Docket No. 52-021
MHI Ref: UAP-HF-11244

Subject: MHI's Responses to US-APWR DCD RAI for Chapter 7, Response to the Additional Questions from the NRC, Revision 8 of the Technical Report MUAP-07005-P "Safety System Digital Platform –MELTAC-", and mark up of DCD Tier 1 on Revision 3

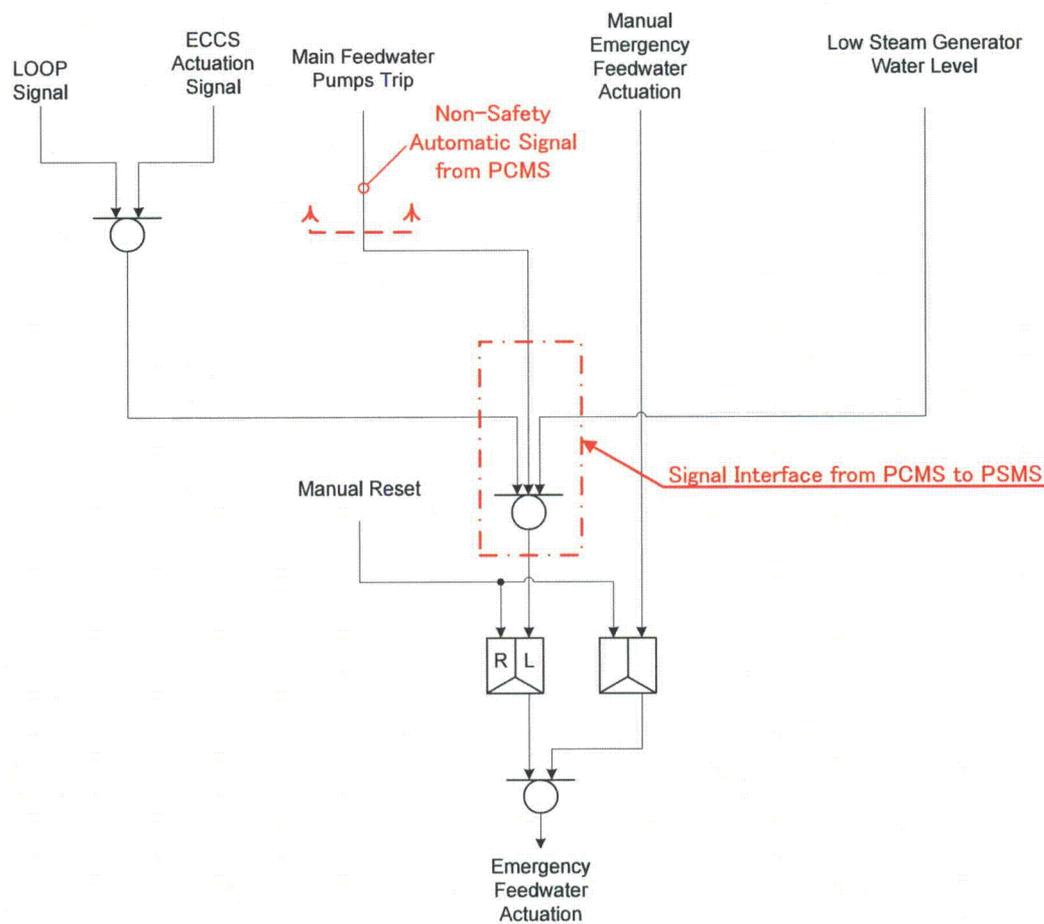
QUESTION NO. : 07.09-24

The interface logics for the non-safety automatic control signals from the PCMS consist of simple "AND" and "OR" logic functions within the PSMS, as shown typically in Figures 1 (a) and (b), below. Therefore, the added complexity for these additional signals and logic functions in the PSMS is very limited. In all cases, safety-related signals in the PSMS have priority over these non-safety automatic control signals from the PCMS.

If the non-safety automatic control signals from the PCMS to the PSMS are interfaced by hardwired cables, the "AND" and "OR" logic functions shown in Figures 1 (a) and (b) are still needed in the PSMS. In addition, for the hardwired cables interface design must require additional hardware devices in the PSMS, such as, binary I/O modules, isolation modules, etc.

The following is added to Section 7.9.1.1.2 of the DCD Chapter 7. See Attachment-1, also.

The interface logics for the non-safety automatic control signals from the PCMS consist of simple "AND" and "OR" logic functions (within the PSMS). Therefore, the added complexity for these additional signals and logic functions in the PSMS is very limited. In all cases, safety-related signals in the PSMS have priority over these non-safety signals from the PCMS.
